The ISO received comments on the topics discussed at the February 14, 2019 stakeholder meeting from the following:

The following are the ISO's responses to the comments.

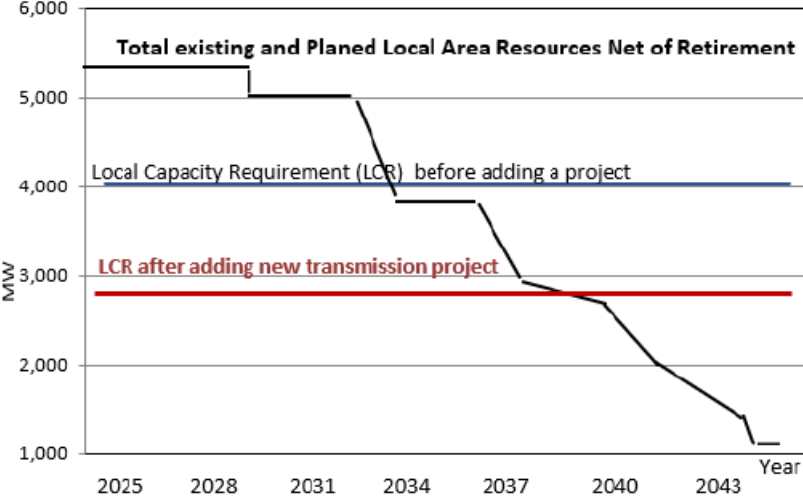
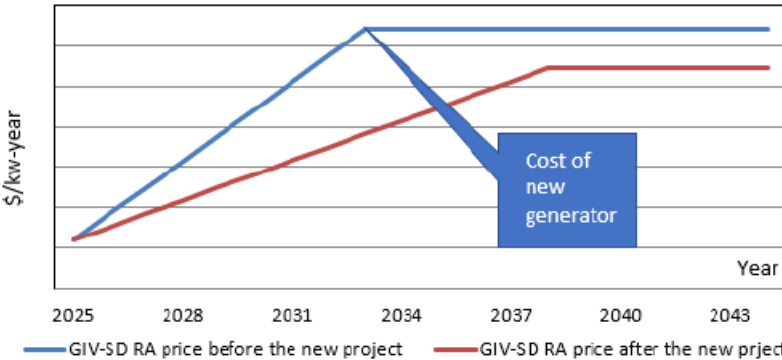
13f	<p>B. RECOMMENDATIONS ON METHODS, POLICIES, AND PROCESSES</p> <p>1. Assumptions on Storage</p> <p>The draft 2018-2019 Transmission Plan states that alternative storage solutions for reliability and Local Capacity Reliability (LCR) reduction projects were considered, but storage costs, analysis and other storage assumptions were not included. To better understand the CAISO's storage solution analysis for replacing gas-fired generation and for mitigating reliability needs, the Public Advocates Office requests that the CAISO provide the assumptions used to evaluate storage as a preferred alternative in each TPP cycle. These storage assumptions should include assumptions on capital and maintenance costs, discharging capacity, charging speed, applicable storage technologies, anticipated charging source(s) and lifecycle timeframe. Going forward, the CAISO should present its storage assumptions during the beginning of the TPP</p>	<p>Regarding the storage projects studied in the 2018-2019 transmission planning cycle, please refer to sections 4.8 and 4.9.11 in particular.</p> <p>The comment also appears to be requesting development of generic planning information for consideration in a future planning cycles. This comment should be submitted into the development of the study plan for future planning cycles.</p> <p>The ISO's preferred approach has been to provide information regarding the characteristics of the needs that were identified, inform stakeholders when possible about particular opportunities for preferred</p>

No	Comment Submitted	CAISO Response
	<p>cycle and include its assumptions in an appendix to the Transmission Plan. The storage assumption presentation and appendix should include information from actual projects and or verified technological advances and the resources consulted to develop storage evaluation assumptions. The Public Advocates Office requests this information in order to confirm that the lowest cost solutions are approved and to assist with revisiting prior storage proposals once the Storage as a Transmission Asset initiative concludes and once the CPUC provides long-term direction on the gas-fired generation fleet.</p>	<p>resources and storage to play a role, and perform more detailed assessments based on alternatives and proposals brought forward by proponents, but will consider the suggestion.</p>
13g	<p>2. Resource Mapping and Transmission Planning Process-Integrated Resource Plan Feedback Loop</p> <p>The Public Advocates Office requests that the CAISO share its updated California Energy Commission (CEC) resource maps in a public stakeholder meeting and identify areas with good resource potential and transmission capacity. The CAISO should specifically identify areas where the CAISO made necessary modifications to the CEC’s resource maps to address interconnection challenges such as in the noted Southern Nevada zone. The Public Advocates Office is making this request because the Transmission Plan assessment of the Integrated Resource Plan (IRP) 42 million metric tons (MMT) scenario portfolio revealed that the identified areas for new renewable procurement in the Kramer- Inyokern, Southern Nevada, Riverside East and Palm Springs and Tehachapi areas will experience significant congestion and or reliability issues that would require mitigation. The CAISO’s recommended mitigations included dropping generation, using SPSs and constructing major capital projects. The draft resource portfolios recommended for the 2019-2020 TPP cycle as part of the CPUC’s IRP proceeding, correct some of these issues observed in the CAISO 2018-2019 TPP 42 MMT scenario portfolio assessment. The Public Advocates Office also requests that CAISO provide additional and more frequent technical information to the CPUC and advise on possible alternative locations and renewable resources, such as wind and or solar paired with storage to achieve lower impacts on existing congestion and renewable curtailment.</p> <p>The Public Advocates Office requests the updated resource maps and mentioned additional guidance be provided as soon as possible to inform the CPUC IRP process which is underway. As stated in the Public Advocates</p>	<p>The comment has been noted. Because the CEC staff develops the proposed resource mapping, the ISO refers PAO to the CEC and the CPUC.</p> <p>During 2018-2019 TPP, the CEC staff provided the ISO with a proposed substation-level mapping for portfolio resources. The ISO presented the details of this mapping and any modifications during the stakeholder meeting held on September 20-21, 2018. (page 13 of “2018-2019 TPP Policy-driven Assessment” presentation)</p>
